**DEPARTMENT OF TRANSPORTATION
STATE OF GEORGIA**

FILE: STP000-0066-01(029) Dodge **OFFICE:** Engineering Services
P.I. No.: 221975
SR 841/Northwest Eastman Bypass **DATE:** October 16, 2009

SUBJECT: IMPLEMENTATION OF VALUE ENGINEERING STUDY ALTERNATIVES

SUBJECT **Value Engineering Study Report Response**

TYPICAL SECTION S. R. 841

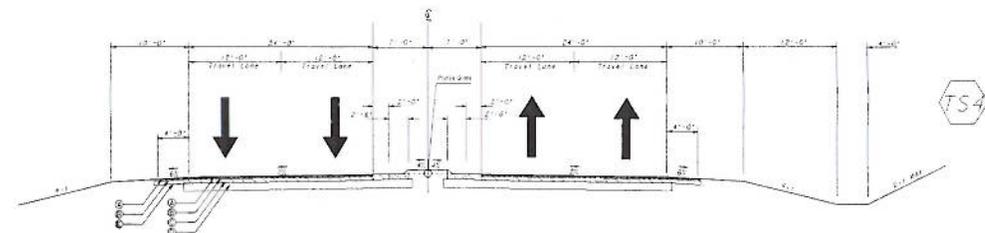
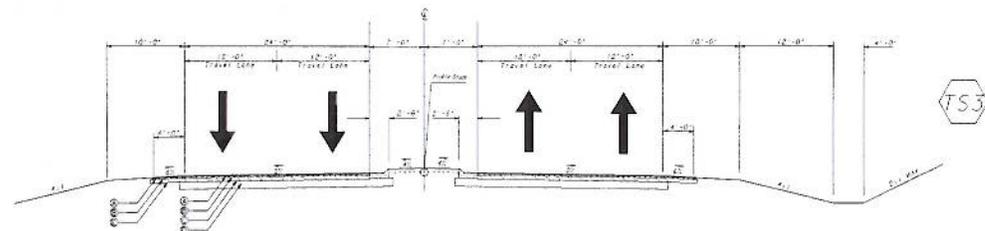
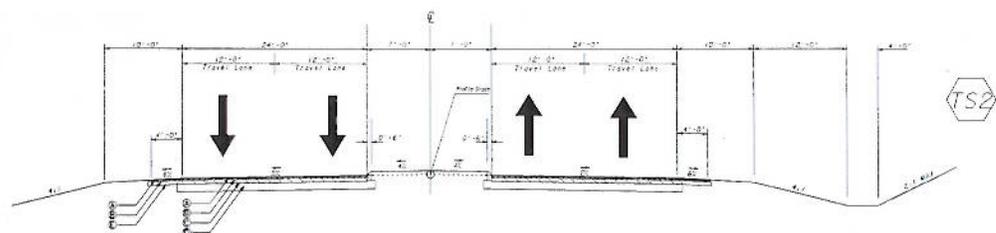
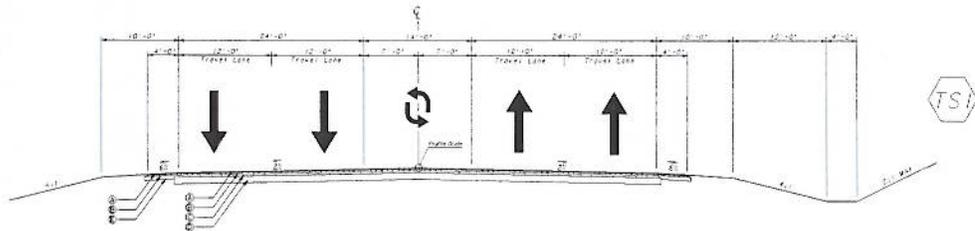
E-3 Use a 14-Foot Non-Depressed Grass Median Instead of A 14-Foot Full Depth Median:

This alternative would change the proposed 14-ft flush median to a 14-ft grassed, raised median with header curb along the inside edge of pavement. See the attached typical sections for further clarification.

However, in order to fully investigate the option identified by the VE study, a total of four typical sections were compared based primarily on safety and cost to determine the best section to apply to this project. A full description of each typical section and the comparison between each is as follows:

The VE alternative does disallow illegal U-Turn maneuvers within the project corridor; but it does so by placing a raised median very close to the inside edge of traffic. In order to fully comply with AASHTO guidelines, the face of that curb must be accompanied by at least a 1-ft, and preferably 2-ft, offset. (A Policy on Geometric Design of Highways and Street, 2004, pg 322, AASHTO).

The safety ramifications of the absence of this offset are increased when the design speed is above 45 MPH, as is the case with this project. Because the VE alternate (TS2) does not allow for the minimal offset to the face of the curb it would require a design exception and FHWA approval. In addition, the absence of a sufficient gutter width in alternate TS2 increases the risk of hydroplaning because the gutter spread must be entirely accommodated within the travel lane.

Because of the considerations of public safety, project costs, need and purpose it is the recommendation of this office to not implement this VE recommendation and maintain the 14-ft flush median (TS1) alternative on this project.
